# Welcome to the Oakridge Co-op information session

The City has finished its review of the combined development permit and land use redesignation for the existing Oakridge Co-op site and will be recommending approval to Calgary Planning Commission.

# Second review – what The City asked

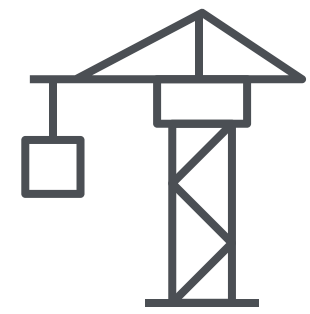
Following the third phase of engagement, The City conducted a second detailed review and technical evaluation of the application. Key areas for amendment on the application were identified based on the review and your feedback. These areas are:

- Remove or amend the design for building E
- Provide additional screening of the loading area for the grocery store
- Provide a pedestrian connection from the courtyard to the adjacent public park
- Restrict public access (emergency access only) to the road proposed adjacent to the park to create a more pedestrian friendly environment
